**HISTORIC PRESERVATION REVIEW BOARD  
STAFF REPORT AND RECOMMENDATION**

Landmark/District:	<b>Mount Pleasant Historic District</b>	(x) Agenda
Address:	<b>1815 Lamont Street NW</b>	( ) Consent
Meeting Date:	<b>November 20, 2014</b>	(x) Alteration/addition
Case Number:	<b>15-004</b>	
Staff Reviewer:	<b>Tim Dennée</b>	(x) Concept

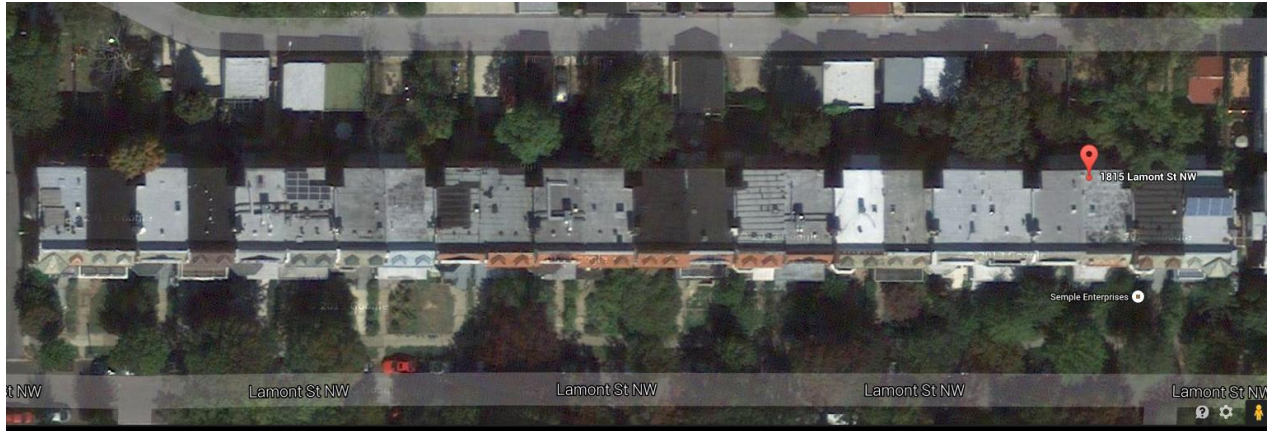
The applicant has removed the roof deck from the drawings. That change reduces the overall impression of bulk somewhat, partly by lowering the addition's center of gravity.

The addition remains three stories tall and stretches from side lot line to side lot line, necessitating the demolition of the three-story ell and the two-story rear porch. But the depth of the main mass has been reduced so that its projection would equal the depth of the row's rear porches, about six and a half feet. The one-story projection remains, but its depth has been reduced to six feet.

The spiral stair remains in its entirety, as it is desired for access to and egress from the upstairs unit.

Yet the cladding materials still need some revision. If the addition is to be three stories, then differentiating the top story is appropriate, although it would better be done with some kind of slate or fiber-cement shingle, i.e., something more closely related to the shingles on the attics of the other houses, and at least of a similar, dark coloration. But the primary wall materials on the rear elevation should return around the addition's sides. Not doing so is acceptable in some circumstances, such as when the sides cannot be easily seen, but here it just makes the brick look false. Changes in material between the main body of the addition, its top story, and its one-story projection do break up the larger mass into finer-scaled parts, but only effectively if the materials continue around.

*The HPO recommends that the Board approve the concept and delegate further review to staff on the condition that the brick and siding on the rear elevation return around the sides of the addition.*
